**Flood Control Project Maintenance
Levee Inspections**

Fall 2019 Levee Maintenance Deficiency Summary Report

**Flood Control Project Maintenance
Levee Inspections****LMA District Cover Sheet****Fall 2019 Levee Inspection Results****Levee District No. 0002 (Glenn County)**

Levee District No. 0002 (Glenn County)

Photo 1 of 1 : FA_2019_LD0002_28_30_20190822_00015.jpg

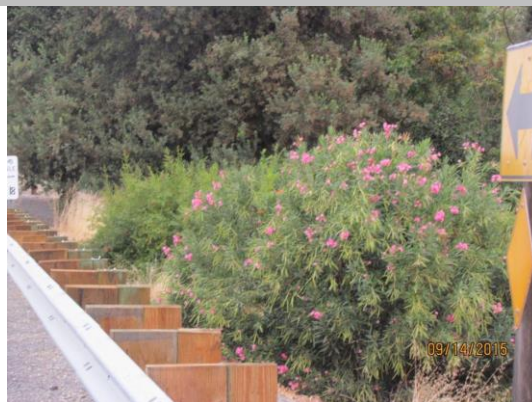
LM Start	1.03	Rating **	M	Issue No.	30
LM End	1.03	Issue Type +	En	Location *	WS
Category	Earthen Levee			GPS Latitude/Longitude	
				Start	End
Item	Vegetation			39.428445 °	39.428445 °
				-122.010972 °	-122.010972 °
DWR ID	DWR_LD0002_01_f_2015_30				
Comment Code					
V6 : Landscaping					
Inspector Comment					
Remove the oleanders from the waterside slope.

Photo 2 of 3 : UCIP_FA_2019_53005_78120.jpg

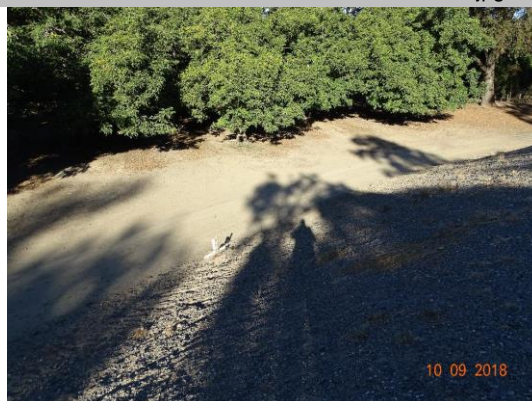
Comment Code						
Inspector Comment						
DS_ID:21176 FS_ID:53005 EP_NO: 15198 Repair Type: Non-Urgent Crossing Status: Not Found UCIP Comments: 10/9/2018 No markers found. Crossing downgraded to "Non-Urgent" due to reclassification of gas lines. (O.Yakimov - DWR UCIP)07/07/2016 same as previous inspection: No markers found. Unable to confirm crossing status. (DWR UCIP - omagana)05/16/2013 No markers found. Need to contact owner to determine if crossing is still active and to determine last inspection date. Will need copy of letter showing crossings passed inspection. (DWR UCIP - omagana) FIELD_STRUCT_DESC: 2-inch steel gas line through the levee, 2.5 feet below the crown. (2-inch gas line authorized under Permit No. 15198, 1989-Northern Michigan Exploration Company) FS Date: 10/9/2018 2:50:03 PM
